Chapter 5 – Dose Modeling RAI Responses

Attachment 1

Sensitivity Chart of Uniform CSM DCGL vs. Increasing CZ Thickness

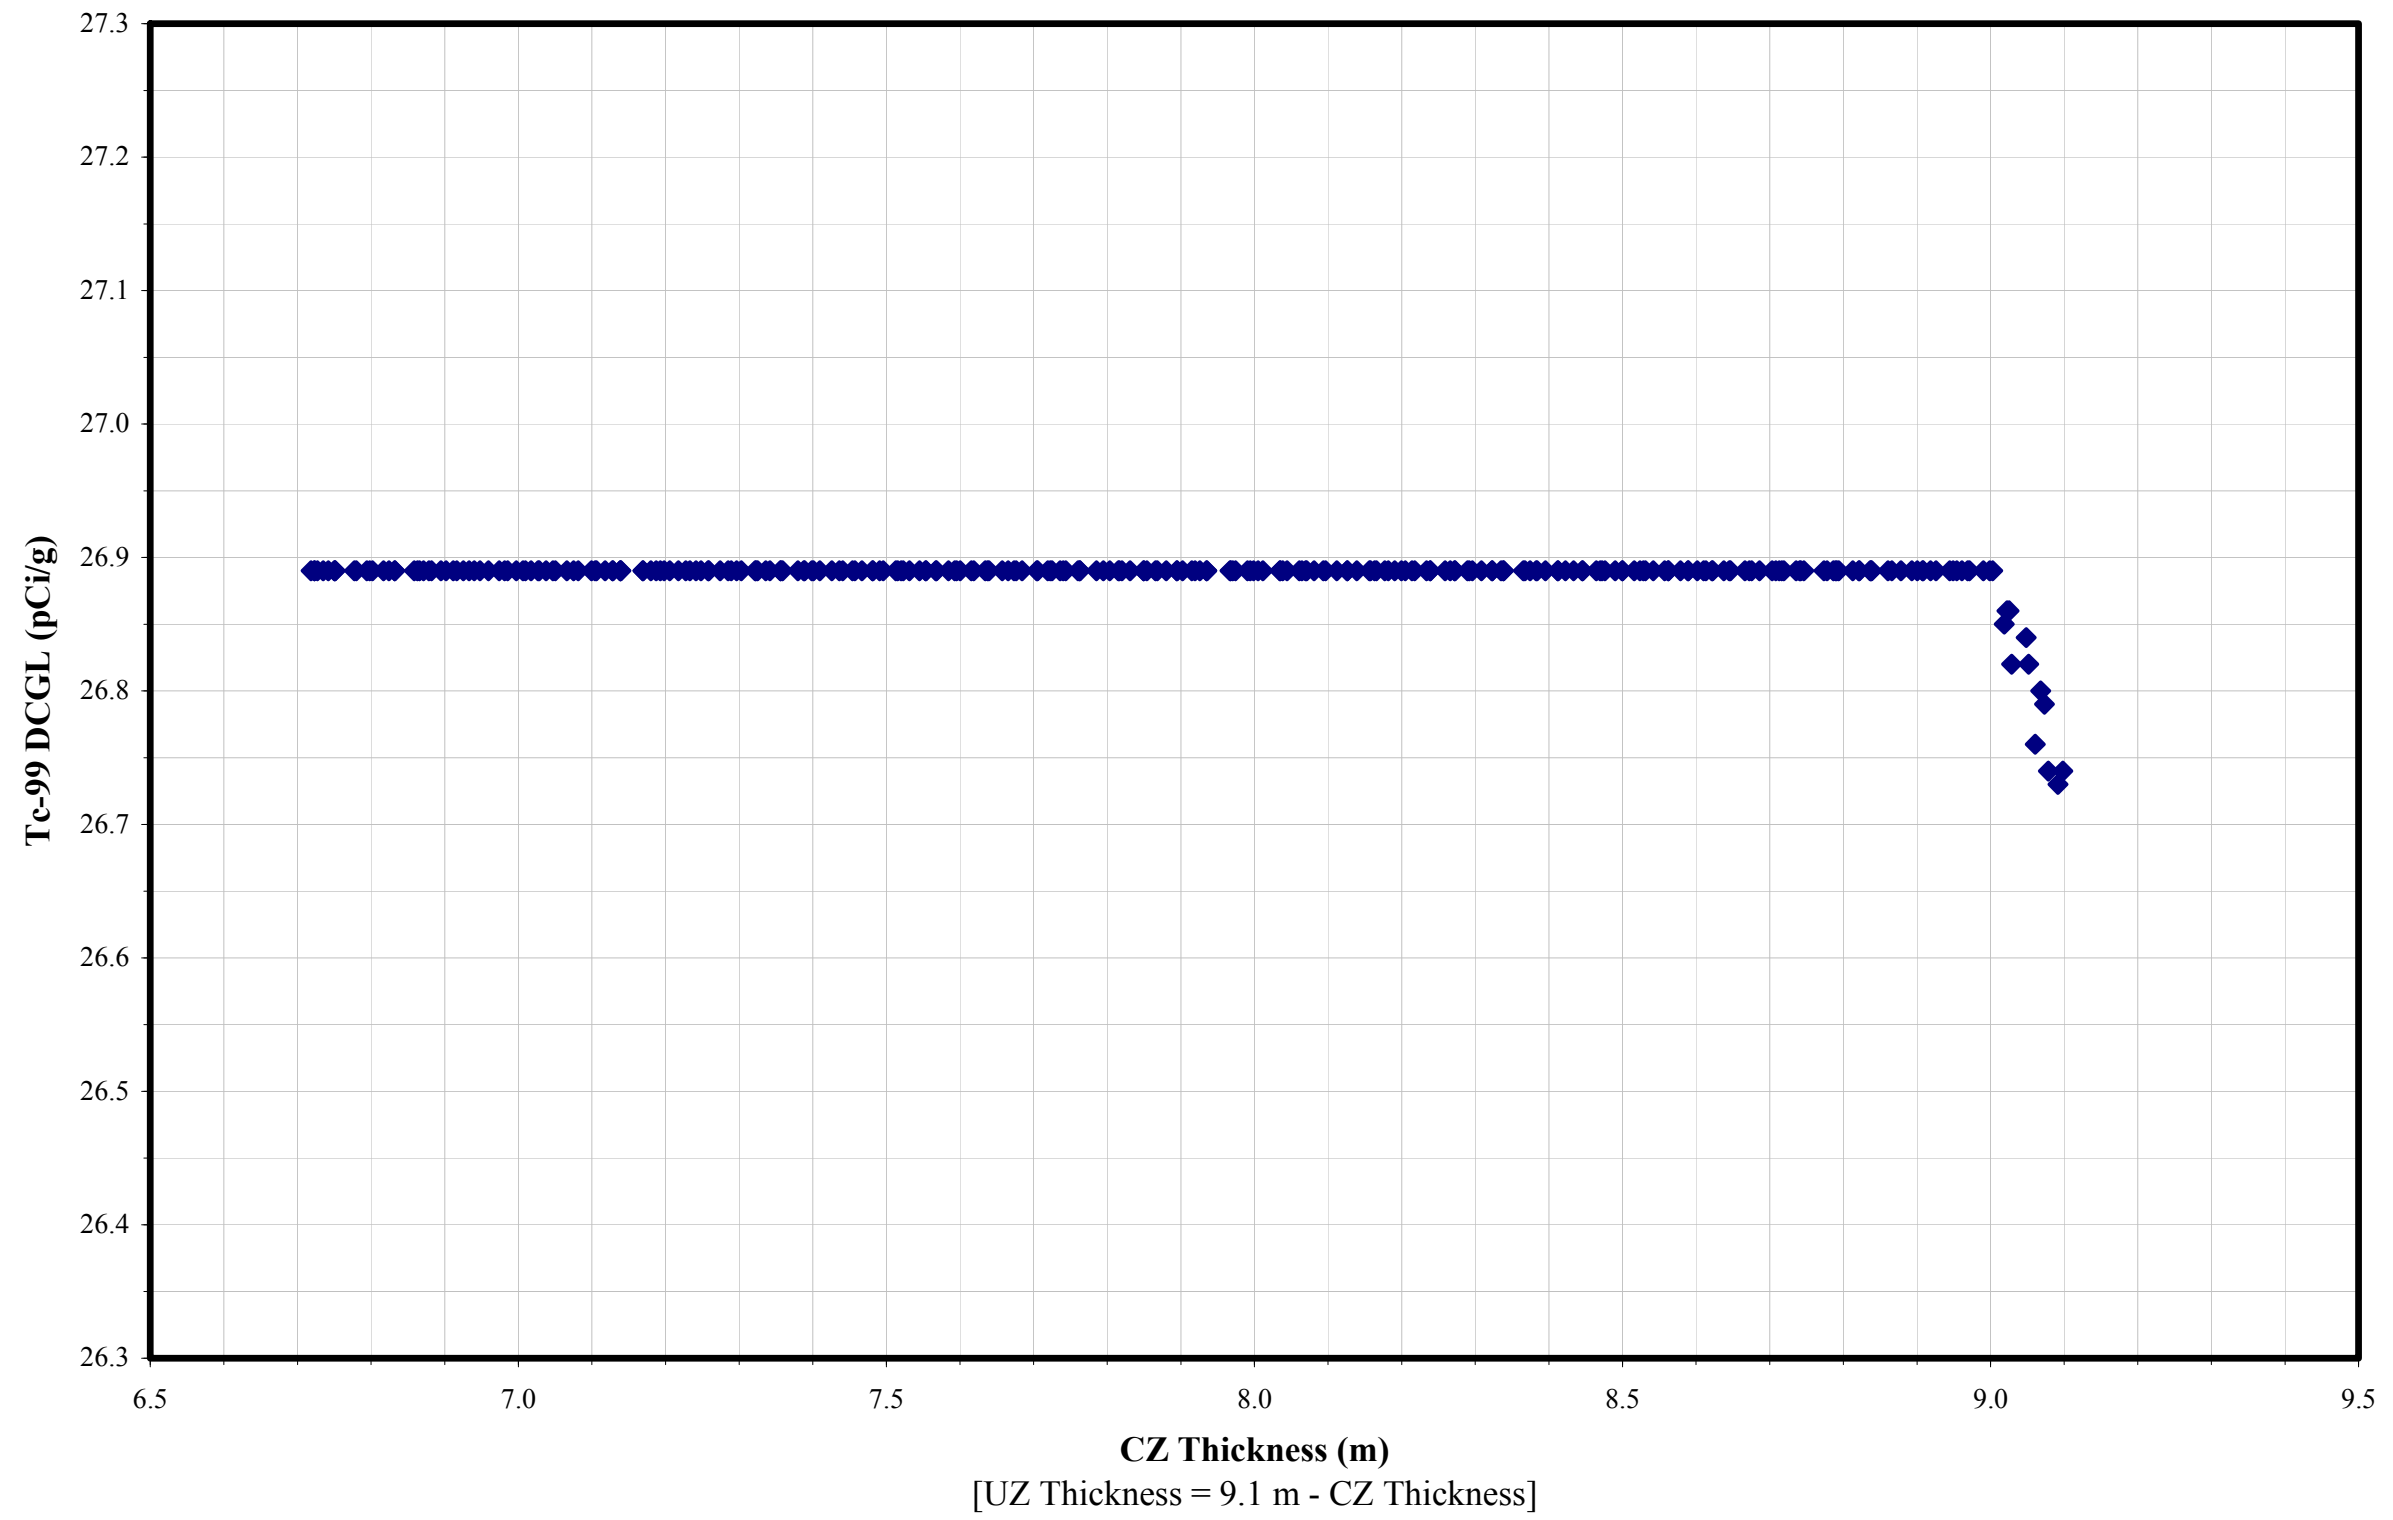
3	<p>Westinghouse showed a sensitivity analysis for the Deep DCGLs but did not discuss how the Uniform DCGLs might be impacted by a similar sensitivity analysis.</p>	<p>Perform a sensitivity analysis showing how the <i>Uniform</i> Tc-99 DGCLs change with variation in the contaminated zone thickness.</p> <p>Send an updated Figure 5-5.</p>	<p>Westinghouse will perform the requested analysis.</p>	<p>1. Westinghouse has performed a sensitivity analysis showing how the Uniform Tc-99 DGCL is affected with variation in the contaminated zone thickness. For the sensitivity analysis, depth of the contaminated zone was varied from 6.7 meters to 9.1 meters while adjusting the size of the unsaturated zone so that the sum of the two remained equal to 9.1 meters. The analysis shows that the model is insensitive to the contaminated zone thickness, as shown in Attachment 1.</p> <p>2. Figure 5-5 has been revised and is provided as Attachment 2.</p>

Uniform CSM Tc-99 Concentration Profile

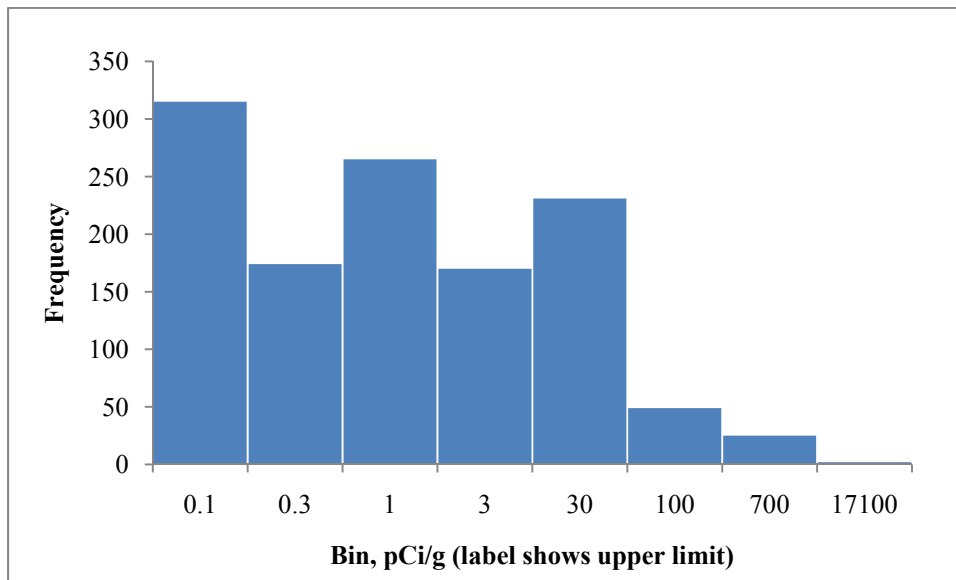
RAI No.	Issues	Path Forward	3/4/11 Discussion Points	Proposed Resolution	NRC Concurrence
6	<p>Conservatism of assumed ratios of radionuclide concentrations in sensitivity analysis is not adequately justified. Some areas of the site have a higher ratio of Tc, than assumed in the sensitivity analyses (i.e., 20%) and the behavior of this radionuclide can be significantly different than other radionuclides.</p>	<p>Perform a sensitivity analysis assuming 100% Tc-99 to see what parameters are sensitive. If additional parameters are found to be sensitive when there is only Tc-99 present, treat these as sensitive parameters in all CSMs.</p>	<p>Westinghouse will perform the requested analysis.</p>	<p>1. Westinghouse performed a sensitivity analysis assuming 100% of the activity was attributed to Tc-99 to determine sensitive parameters. The analysis showed that in addition to the parameters noted as sensitive in Table 5-5 of the Hematite Decommissioning Plan (HDP), the Milk Transfer Factor was a sensitive parameter for only the Uniform CSM. The effect on the DCGL (when recalculated using the 75th percentile of the distribution from NUREG-6697) was relatively minor, and resulted in a maximum reduction of approximately 2%. Attachment 5 provides the sensitivity analysis results and a comparison of DCGLs.</p> <p>As a further refinement to this evaluation, the sensitivity analysis for the Uniform CSM was repeated, using a distribution representative of actual site conditions for the Tc-99 concentration and the average concentration values for all other radionuclides. The radionuclides used in the analysis are shown in Attachment 6. The analysis indicated that the Milk Transfer Factor was not a sensitive parameter.</p> <p>In consideration that the sensitivity for milk transfer factor had only minor impact for the 100% Tc-99 case, and was not identified as a sensitive parameter in the second assessment that was based on actual site conditions, Westinghouse will continue to treat this factor as an insensitive parameter (consistent with the sensitivity analysis presented in the DP).</p>

Attachment 6
Radionuclide Concentrations Used in Actual Site Conditions Sensitivity Analysis
